Technical Service Information

THM 440-T4 TCC APPLY ON 1-2 SHIFT

Figure 1

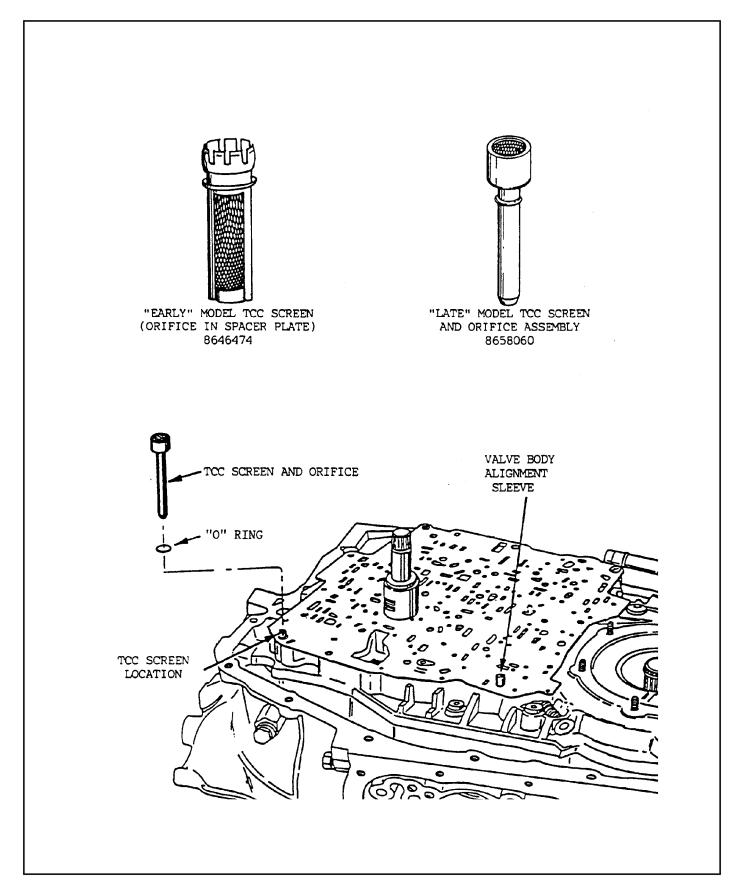
The converter clutch applies immediately after the transaxle has shifted to 2nd gear, and cannot be released with the brake pedal. The converter clutch will apply on the 1-2 shift even with the wire harness disconnected from the transaxle.

- (1) The TCC screen and orifice assembly missing from its location in the spacer plate (See Figure 1).
- (2) The TCC screen and orifice assembly "Melted" and usually found in the TCC solenoid, blocking the exhaust passage. Usually an aftermarket product, not OEM.
- (3) The TCC solenoid blocked with foreign material.
- (4) TCC solenoid for Canadian application, which is self grounded, installed on a computer controlled transaxle (See Figure 2). NOTE: Will not lock-up with wire harness disconnected.

- **CORRECTION:** (1) Install the TCC screen and orifice assembly, with the "0" ring, in its proper location in spacer plate (See Figure 1). OEM part numbers are found below.
 - (2) Replace TCC screen and orifice assembly with OEM PART NUMBER 8658060, and replace TCC solenoid assembly with the proper part number.
 - (3) Replace the TCC solenoid assembly with the proper part number. (4) Install the PROPER TCC solenoid assembly. If your valve body is equipped with the TCC Throttle Valve line-up, it requires the self grounded solenoid, I.D. stamped 732 (See Figure 2). If your valve body is not equipped with the TCC Throttle Valve line-up, it requires the computer controlled solenoid, I.D. stamped 419 (See Figure 2).
